ADDENDUM TO BID DOCUMENTS

<p>Pleasanton Unified School District</p>	ADDENDUM 01
	Project: Onsite Drop Off Landscape at Foothill High School Project (2021-22.16)
	Date: April 22, 2022

Project Title Foothill High School On Site Drop Off Landscape	Original Drawing	Drawn By MR	Sheet Number AL3.2
Project Number 2021-22.13	Issued With Addendum 1	Issued Date April 22, 2022

QUICK COUPLING VALVE NOT TO SCALE

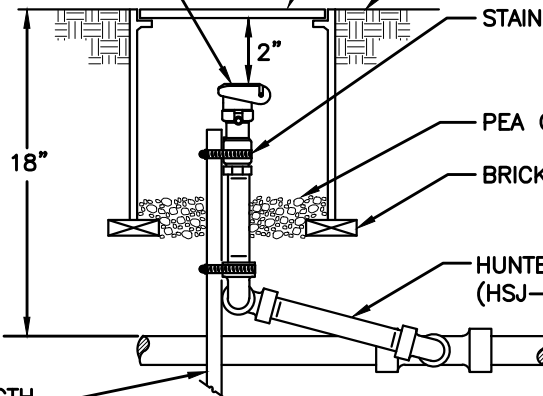
1. Subject: Add two Quick Coupler.

Reference: AL3.2

Description of Change: Add two 44RC Rain Bird Quick Couple and 44K Valve key. Location provide by District.
